## United States Department of the Interior

## BUREAU OF LAND MANAGEMENT

Re: Minor Modification, Resource Recovery and Protection Plan (R2P2), Southeast Longwall Area  
West Ridge Mine

MINOR MODIFICATION TO  
MINING PLAN APPROVED BY  
BUREAU OF LAND MANAGEMENT  
Recommended By:

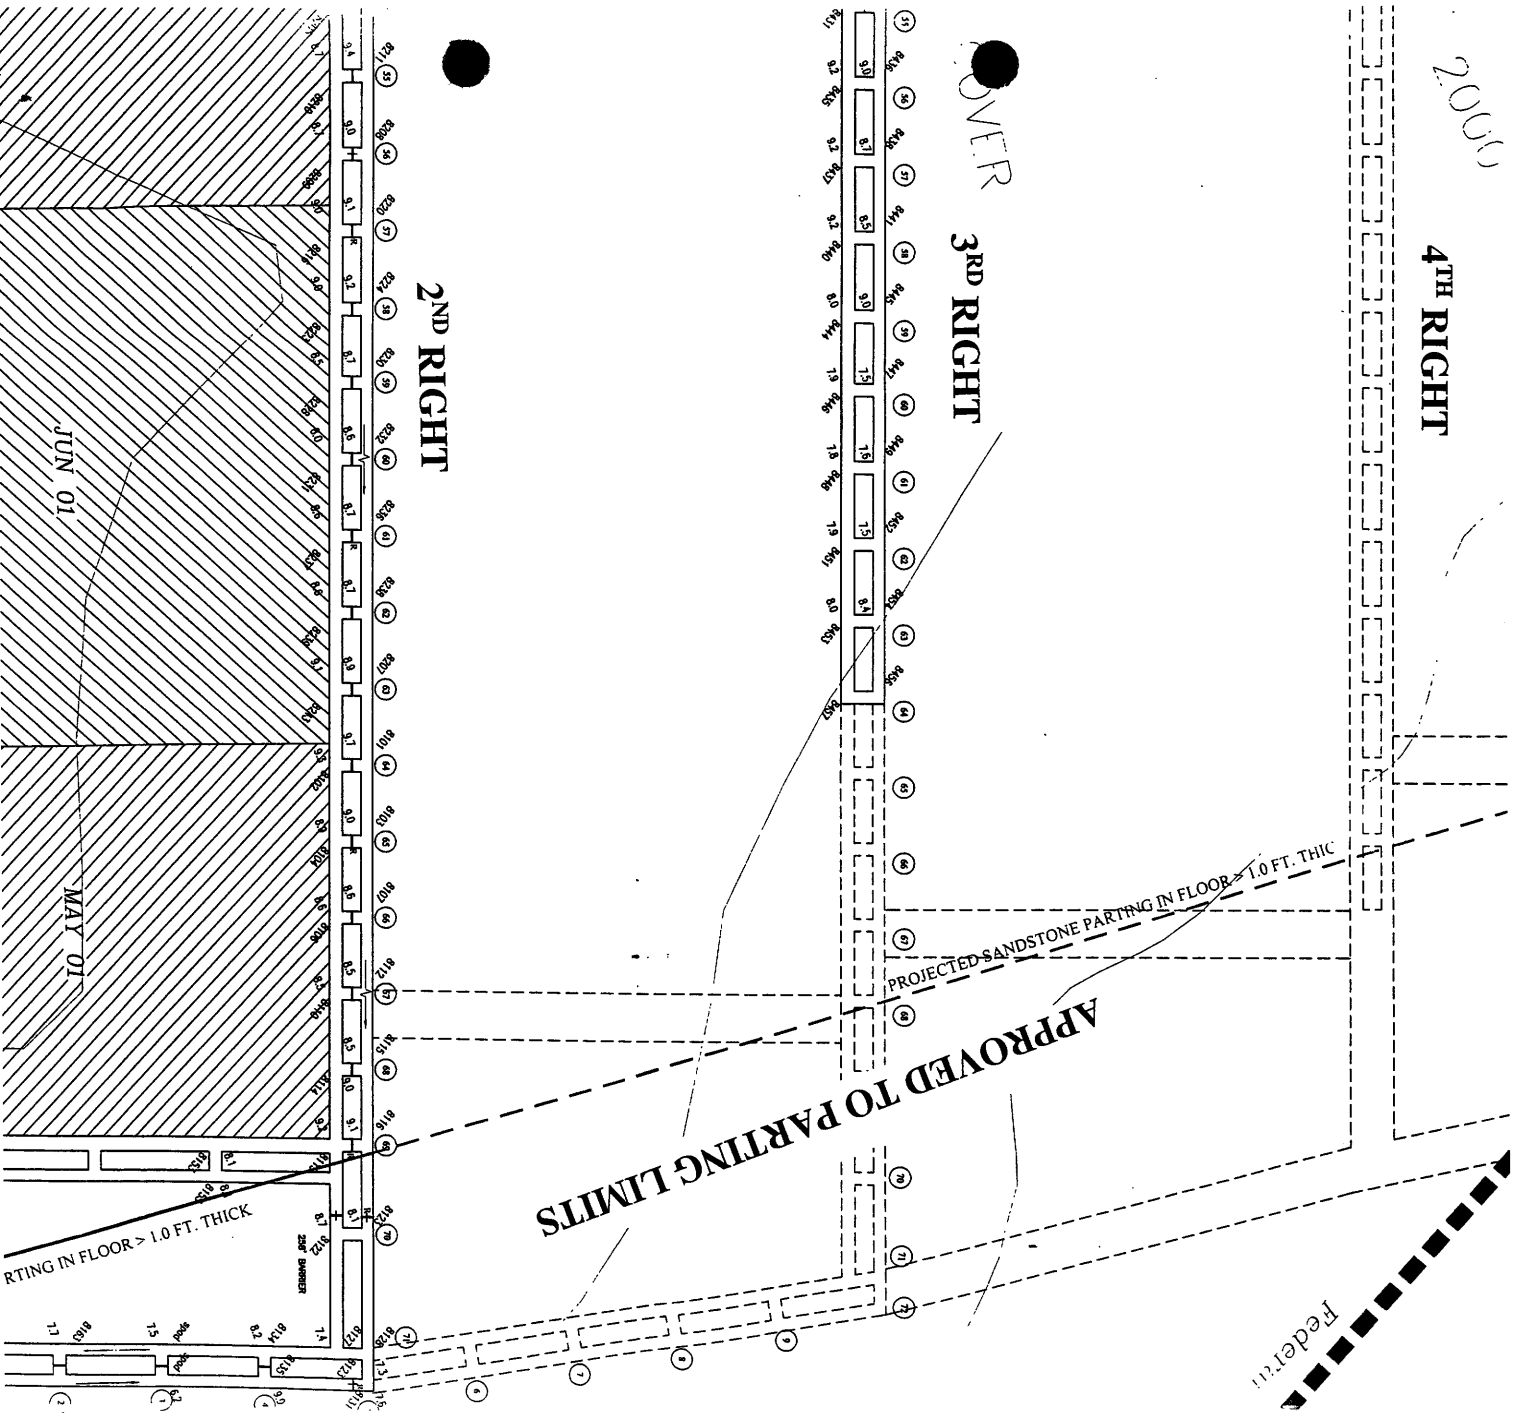
West Ridge proposes to mine the longwall set-up entries between 1<sup>st</sup> and 2<sup>nd</sup> Right gateroads at crosscut 69 in 2<sup>nd</sup> Right and mine the bleeder entries 300 feet beyond the set-up entries. This change would shorten the longwall panel by about 300 feet from the original projection. West Ridge also plans to develop successive gateroad entries to the limit of the rock split. The company reports encountering a rock split in the coal that has left a minable seam thickness of less than 6 feet.

The BLM has inspected the area in question and has noted the rock split. A split in the coal of up to 2 feet was mapped and the trend of the increase was noted. BLM agrees that further mining of the 2<sup>nd</sup> Right gateroad would produce coal of unacceptable quality and the mining of the set-up room at crosscut 69 would avoid the rock split and still maximize longwall recovery. We also agree with a general modification for the next gateroads that would likely run into the split. The noted trend of the split would most likely extend into the next proposed longwall panels (panels 2 and 3). A general modification would allow mining up to the rock split and allow maximum longwall recovery.

West Ridge's proposed changes to the R2P2 complies with the Mineral Leasing Act of 1920, as amended, the regulations at 43 CFR 3480, the lease terms and conditions, and will achieve maximum economic recovery of the Federal coal. The new layout for panel #1 with set-up rooms at crosscut 69 is approved as submitted. A general modification is also approved for panels 2 and 3 based on the encountering of the rock split that would curtail further development. West Ridge is to inform the BLM when these conditions are encountered for verification and to approve longwall set-up entries and bleeders. A copy of the approved mine map is enclosed.
